Access Compliance Report

Public Rights-of-Way

Intersection ID: 47979	Main Street: SPRINGS_MILL_RD	Cross Street: RAFFIA_RD	Location: NW
ADA ID: 508BA0180BC9	Ramp Type: PerpDiag	Initial Pass/Fail: Fail	Overall Compliance: No
		Severity Score: 10

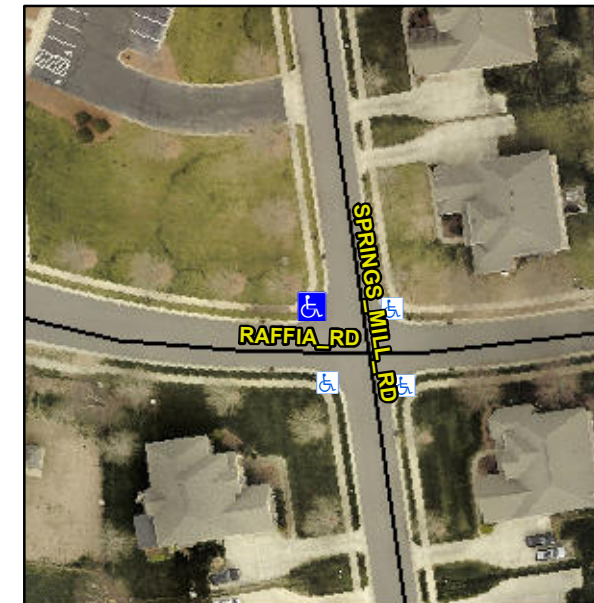
Not Found, R304.5.1, R304.5.3

Compliance	Description	Data	Compliance	Description	Data
N/A	Ramp Length (in)	41.0	Yes	Ramp Slope (%)	5.7
No	Ramp Width (in)	43.0	No	Ramp XSlope (%)	3.8
N/A	Flare Type LT	N/A	N/A	Flare Type RT	N/A
N/A	Flare Slope LT (%)	N/A	N/A	Flare Slope RT (%)	N/A
N/A	Flare Traversable LT?	N/A	N/A	Flare Traversable RT?	N/A
N/A	Landing Length (in)	N/A	N/A	DWS Provided?	N/A
N/A	Landing Width (in)	N/A	N/A	DWS Contrast?	N/A
N/A	Landing Slope (%)	N/A	N/A	DWS Length (in)	N/A
N/A	Landing X Slope (%)	N/A	N/A	DWS Full Width?	N/A
N/A	Landing Curb? (Y/N)	N/A	N/A	DWS Offset (in)	N/A
N/A	Shared Landing?	N/A			
N/A	Gutter Ponding?	N/A	N/A	Gutter Slope (%)	N/A
N/A	Gutter Lip Ht (in)	N/A	N/A	Gutter X Slope (%)	N/A
N/A	Painted X Walk1?	No	N/A	Painted X Walk2?	No
	X Walk 1 Direction	To S		X Walk 2 Direction	To SE
N/A	X Walk 1 Width (in)	N/A	N/A	X Walk 2 Width (in)	N/A
	X Walk 1 Slope (%)	1.2		X Walk 2 Slope (%)	4.2
	X Walk 1 X Slope (%)	3.2		X Walk 2 X Slope (%)	1.1

Remove & Replace Curb Ramp With Two New Directional Ramps or Equivalent.
